From: Development <development@bundaberg.qld.gov.au>
Sent: Thursday, 5 August 2021 10:45 AM
To: Planning Internal Referrals <PlanningInternalReferrals@bundaberg.qld.gov.au>
Subject: 522.2021.266.1 - MCU - 373 Back Windemere Road & Coral Cove Drive Innes Park (Relocatable Home Park)

**BUNDABERG REGIONAL COUNCIL
DECISION UNDER DELEGATED AUTHORITY**

APPLICATION NO.	522.2021.266.1
PROPOSAL	Material Change of Use for Relocatable Home Park
APPLICANT	Coral Cove MHE
OWNER	Boral Resources (Qld) Pty Ltd
PROPERTY DESCRIPTION	Lot: 2 RP: 159671, Lot: 1 RP: 159671
ADDRESS	373 Back Windermere Road INNES PARK, Coral Cove Drive INNES PARK
PLANNING SCHEME	Bundaberg Regional Council Planning Scheme 2015
ZONING	Emerging Community Zone
OVERLAYS	<p><u>Lot 1: RP159671</u></p> <ul style="list-style-type: none"> • Acid sulfate soils overlay - within Area 2 (5-20m) • Agricultural land overlay - class B:Limited crop land • Bushfire hazard overlay code - within Medium Potential Bushfire Intensity Area • Coastal protection overlay - within Sea Turtle Sensitive Area • Steep land (slopes >15%) overlay <p><u>Lot 2: RP159671</u></p> <ul style="list-style-type: none"> • Acid sulfate soils overlay - within Area 2

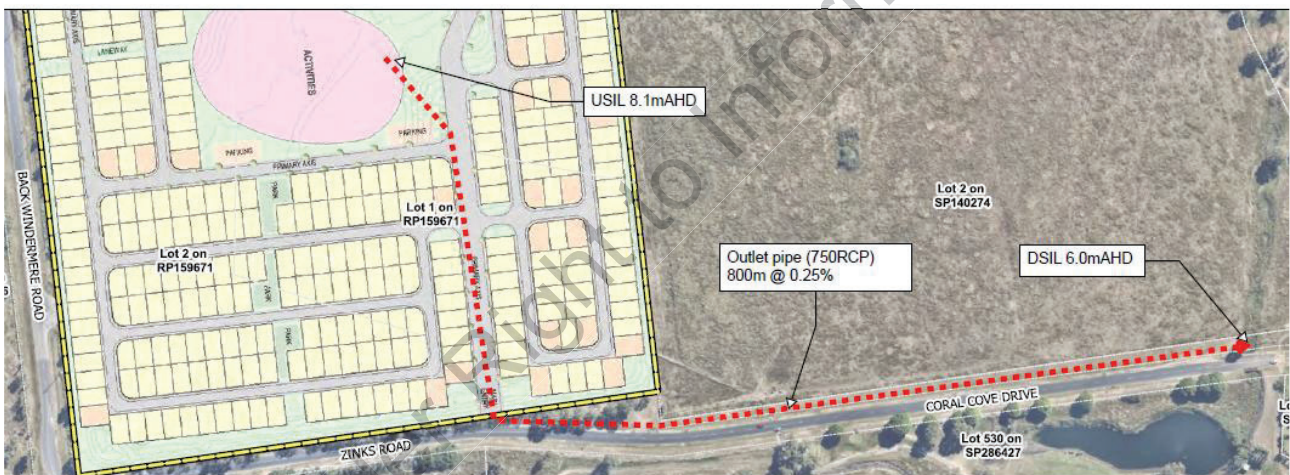
Since no forward network planning has been done for this area as the site sits outside the Council's Priority Infrastructure Area (PIA) sewer declared area, the developer is required to undertake relevant network studies to observe the best strategy for sewer servicing of the proposed development. The applicant advised that provision of on-site treatment be an option, however given the close proximity of Council's existing sewer infrastructure, this would not be the best outcome to meet PO3 of the Works, Services and Infrastructure Code. It would be Council's preference that the development connect to the Deering Place Sewer Pump Station, however it is noted that this strategy would require securing an easement over neighbouring property. Although this is able to be conditioned, Council is aware of the potential issues this can cause to the development's progress.

It is recommended that an either or condition be included to give the applicant flexibility when determining a sewer strategy:

- a) The proposed development gravitate to the Deering Place sewer pump station with all extension of the main to be placed under easement; or
- b) The proposed development connect to the existing rising main at the intersection of Innes Park Rd/Back Windermere Rd. Any additional sewer pump stations required for this option must be internal to the development, considered private and must be owned, operated and maintained by the development.

It is also recommended that a sewer planning report be submitted to Council for the final sewer strategy. This report must include layout(s) demonstrating the internal sewer network, external connection points to council's existing sewer network and any additional sewerage pump stations required.

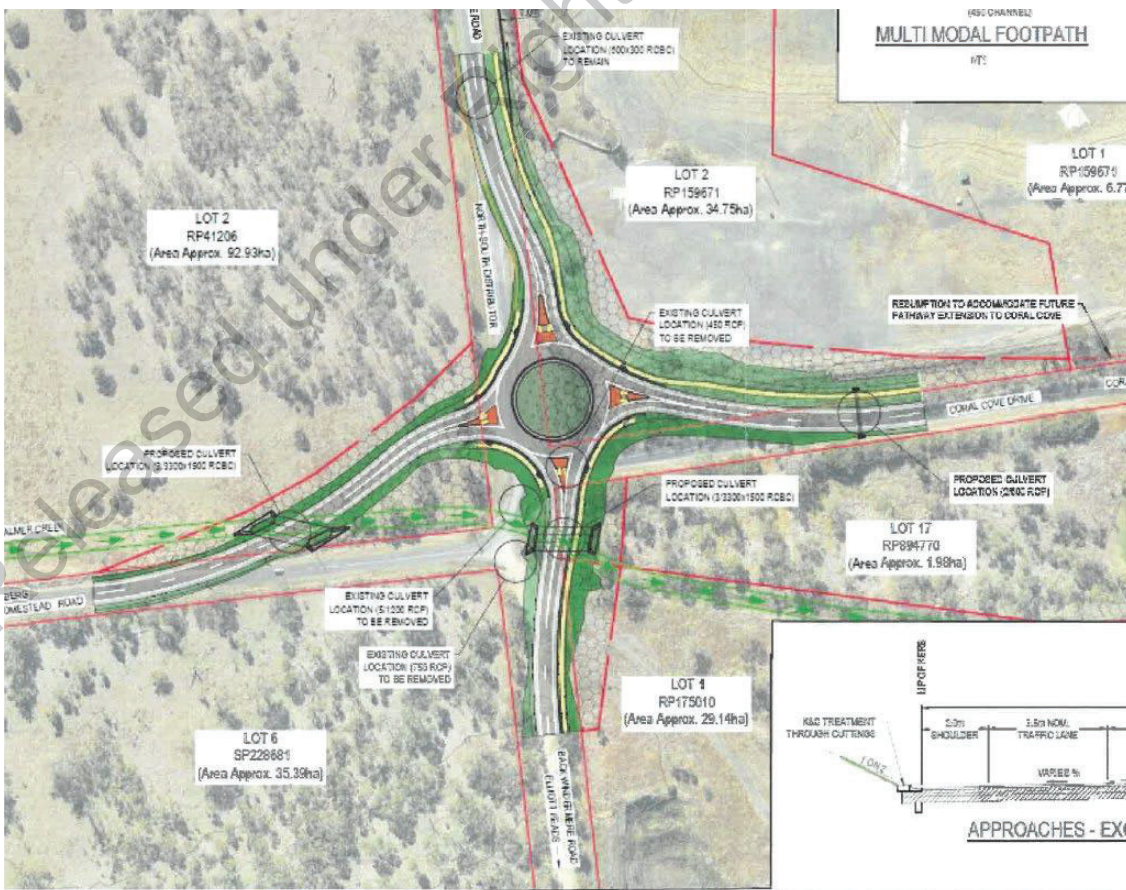
Of further particular interest is the high-level assessment for the road corridor width required for Back Windermere Road between Coral Cove Drive and Innes Park Road that has been undertaken, noting Council's intention to extend the North-South Distributor and the Multi-Modal Pathway, identified within the Road Investment Strategy and the Active Transport Strategy. The high-level assessment showed that a further 7m into Lot 2 on RP159671 fronting Back Windermere Road is required to facilitate Council's future needs.

The applicant submitted a geotechnical investigation report which notes this resumption would bring the new road reserve in close proximity to internal cliff faces. The quantitative slope assessment determined the current state of the existing slopes required exclusion zones around the cut faces located towards the centre and northern ends of the western boundary and within the western section of the northern boundary.

Based on the assessment, the risks have generally been assessed to be outside the tolerable risk to life. It was recommended that exclusion zones are installed at the top and bottom of these areas. Due to this, Council's Roads and Drainage section reassessed their preference for the road widening along Back Windermere Rd to now be on the western side of the existing road corridor.

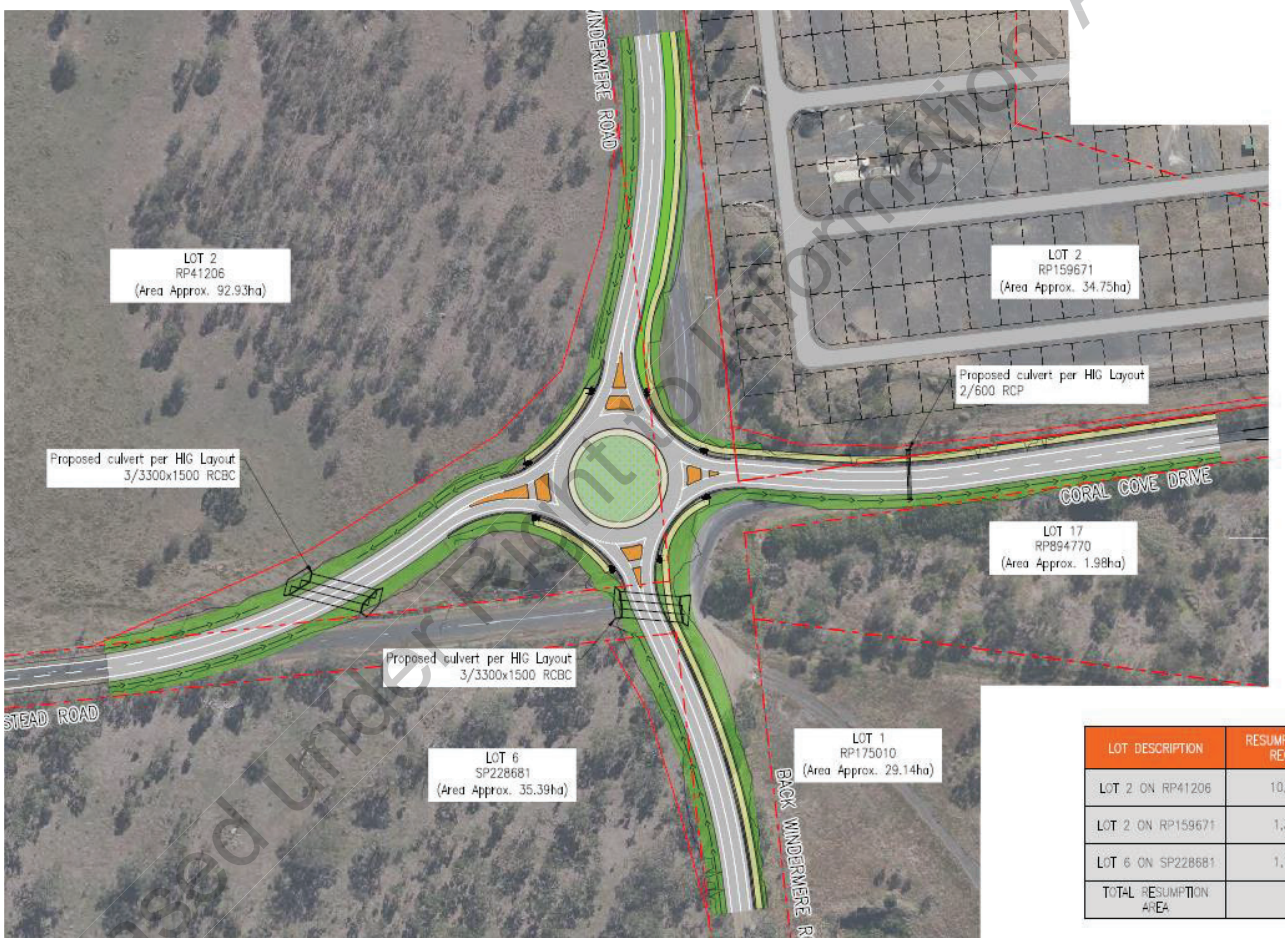
Council entertained the applicants request to further determine if the roundabout location could be moved west, thus requiring less land resumption from the development parcel. The applicant proposed the following location, which reduced the amount of required land resumption from the proposed development site and confirmed that the roundabout option proposed complied with the following design criteria:

- Design vehicle for the north, south and west approaches are a B-Double;
- Design vehicle for the east approach is a 19m semi-trailer;
- Approach geometry adequately slows motorists to a safe roundabout entry speed in accordance with Austroads for 90km/h design speed environment; and
- Other geometry is generally in accordance with Council's current preferred roundabout option (i.e. 3.5m nominal traffic lane widths, 2m sealed shoulders on the approaches).

Council is confident of the new location proposed although the intersection is not required to be built at the time of this development, rather it should be conditioned that an upgrade to this intersection to cater for the additional development demands be constructed instead. Unfortunately to date no intersection analysis has been undertaken by the applicant due to attention being given to the construction of the ultimate design (roundabout). Since this is not the desired outcome at this stage for Council, it is recommended that the applicant be conditioned to undertake intersection analysis at this location and determine at what stage of development upgrades to the intersections configuration is required, with those works to be undertaken at the announced stage of development requiring them.

It is further recommended that the land resumption for the ultimate design (roundabout) be taken in accordance with RMA's "Concept Distributor Intersection Layout" drawing C-SK008, revision A, dated 17 November 2021.
